April 15, 1983
AEP:NRC:0637M

Donald C. Cook Nuclear Plant Unit No. 2
Docket No. 50-316
License No. DPR-74
UNIT 2, CYCLE 4 SAFETY EVALUATION REPORT:
RESPONSE REGARDING PLANT TRANSIENT METHODS

Response to the Plant Transient Analysis
Issues Identified in the NRC Safety
Evaluation Report (SER) for D. C. Cook
Unit 2, Cycle 4

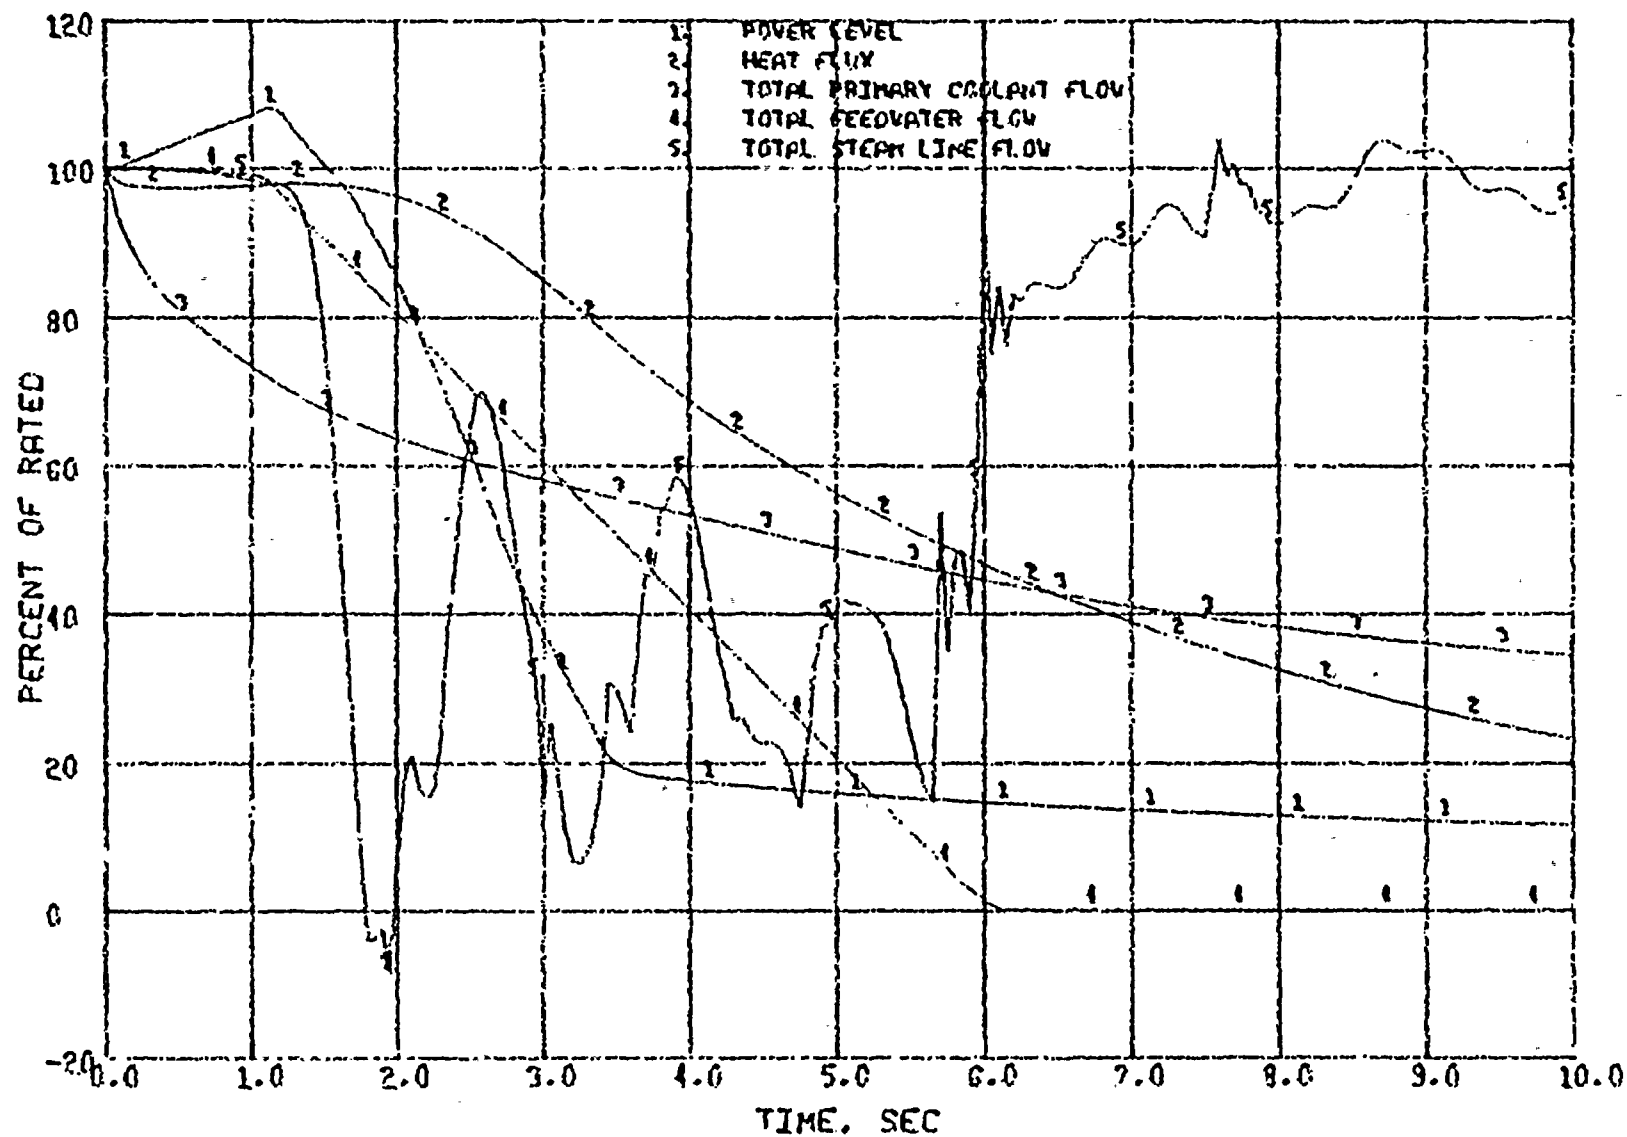
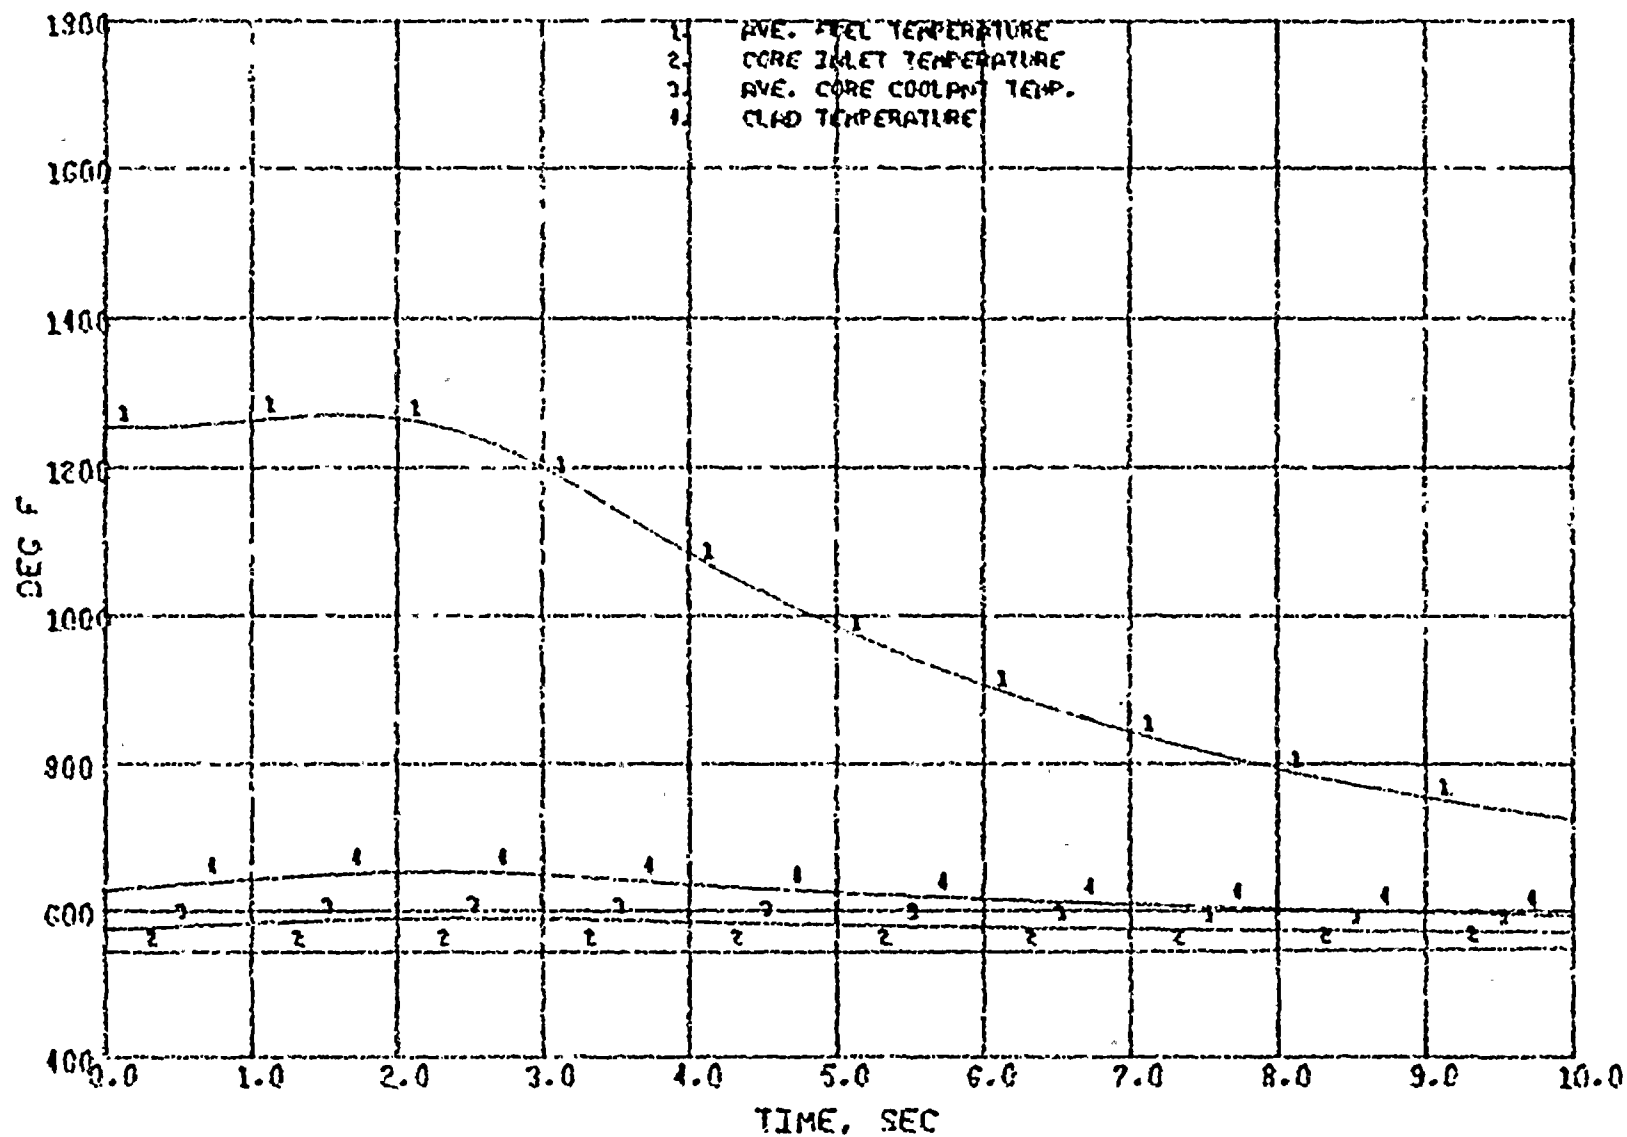
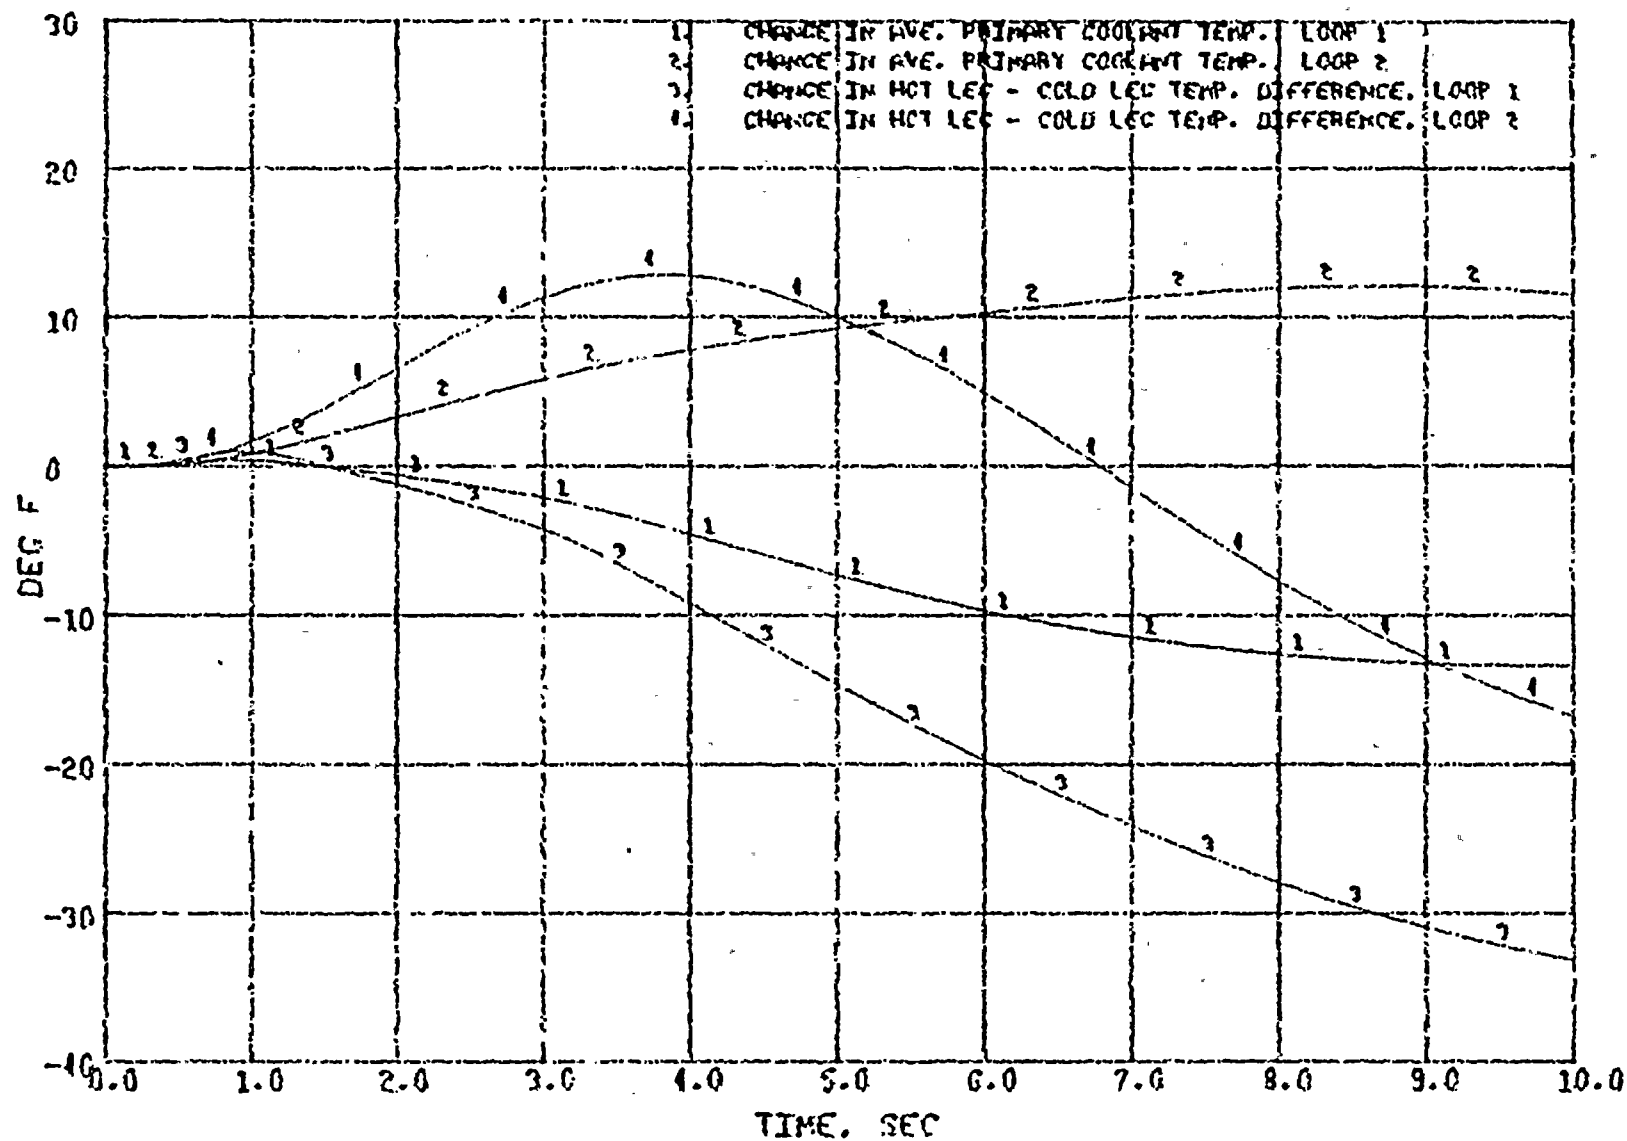
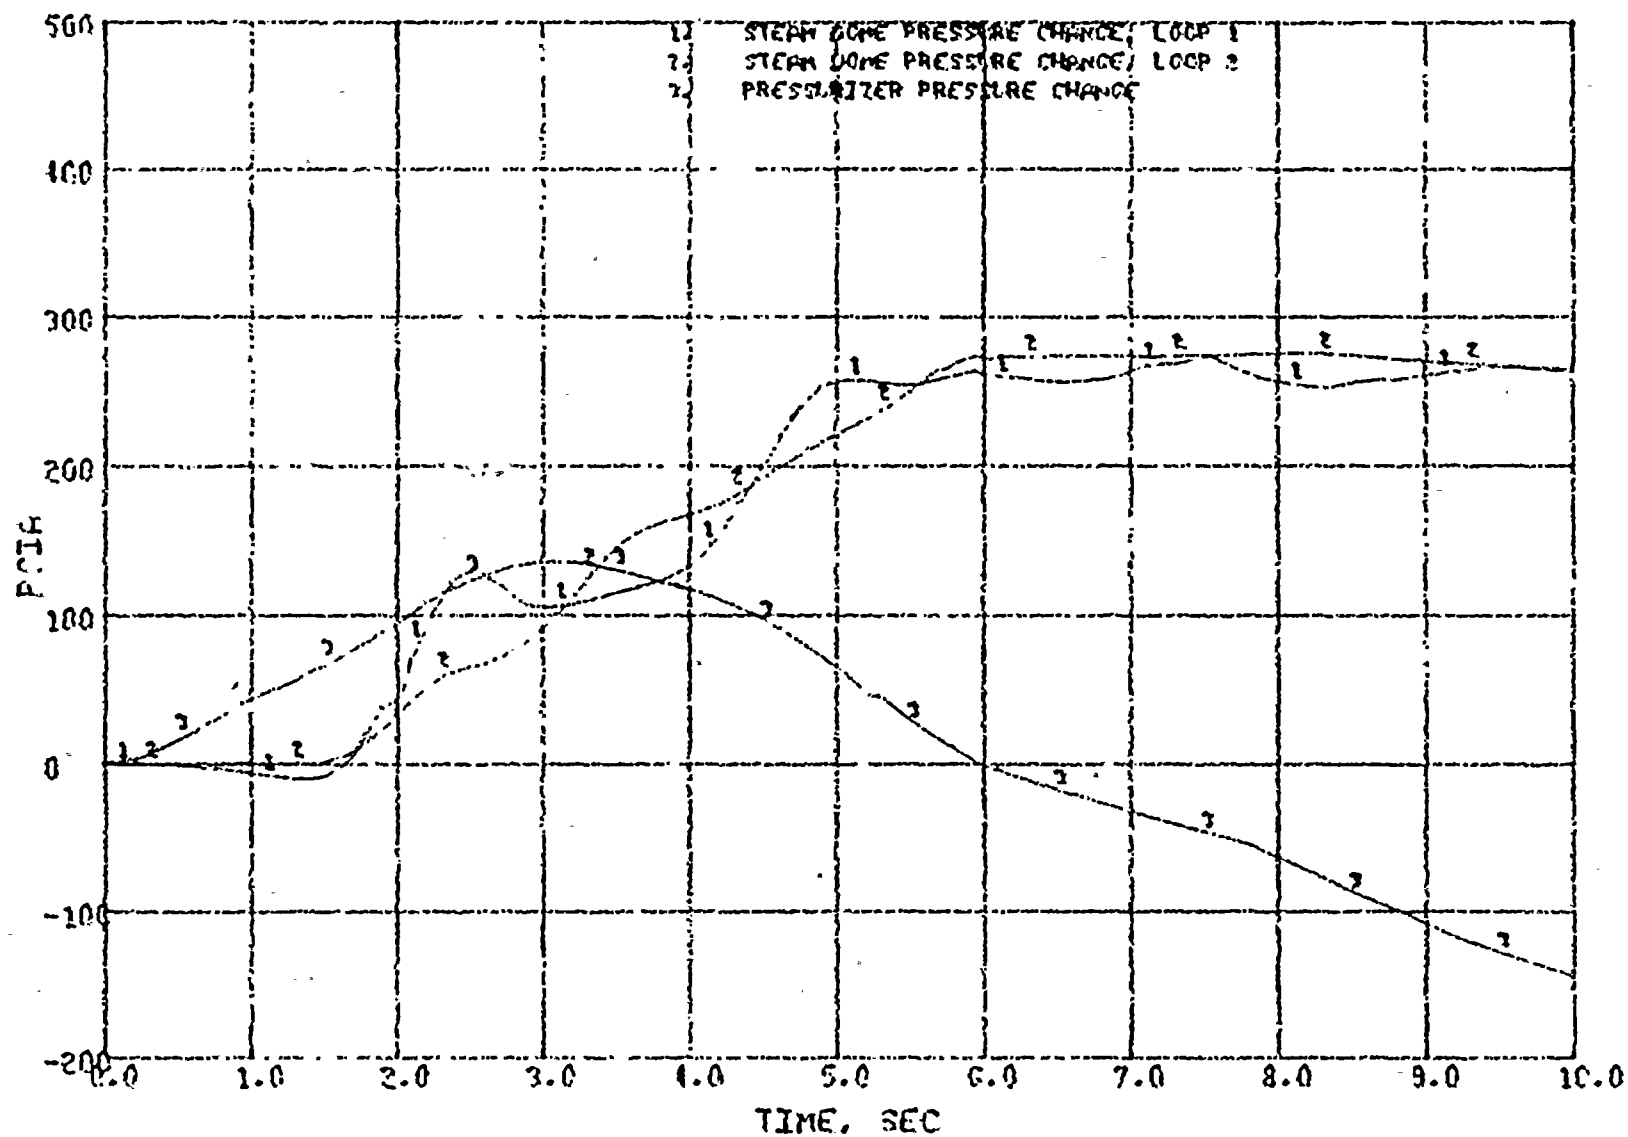
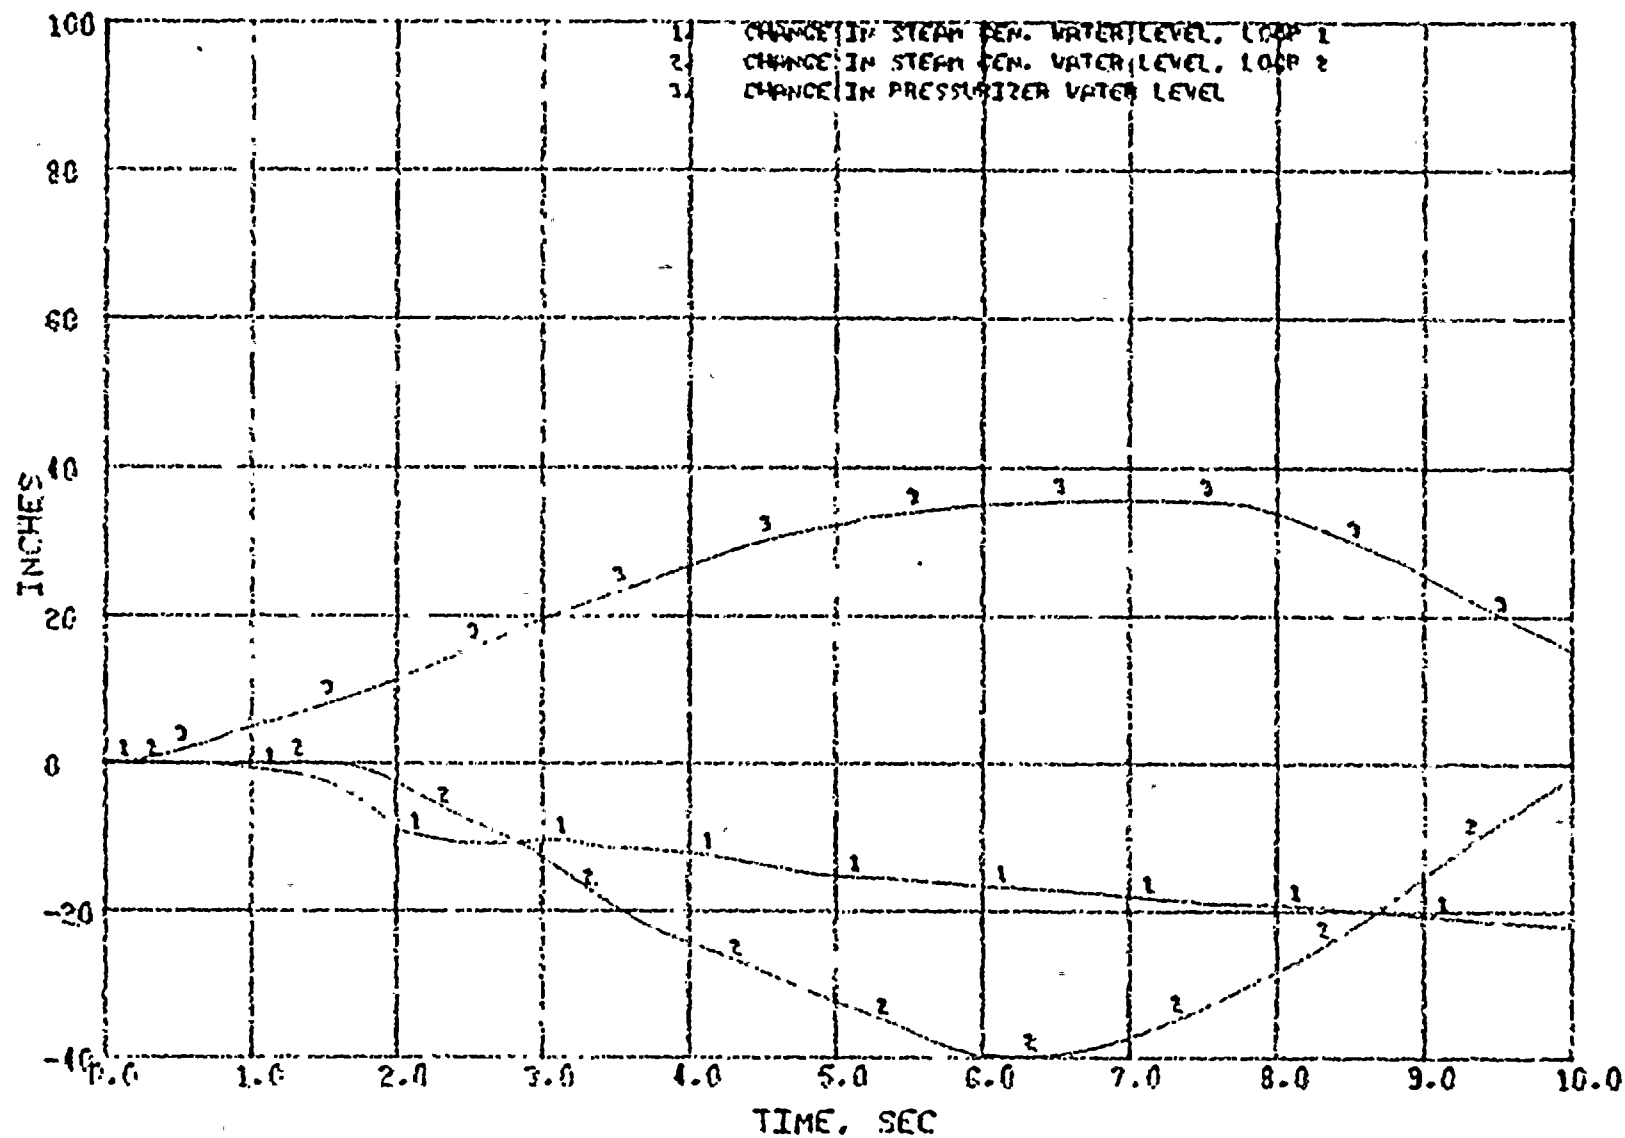
Item 1.2: Provide a confirmatory analysis which demonstrates that specified acceptable fuel design limits are not violated for the case of loss of offsite power. Justification for any delays assumed between reactor/turbine trip and loss of offsite power must be provided.

The requested simulation is attached. Inputs and methodology are identical to those used in Case 1, reported in XN-NF-82-32(P), Rev. 1, except that coastdown of the three remaining primary coolant pumps is assumed to occur simultaneously with the occurrence of the locked rotor. No delay is assumed between reactor trip and loss of offsite power. The calculated MDNBR is 1.34, only slightly degraded relative to the locked rotor case 1. Attached Figures 1-6 display the calculated system response.
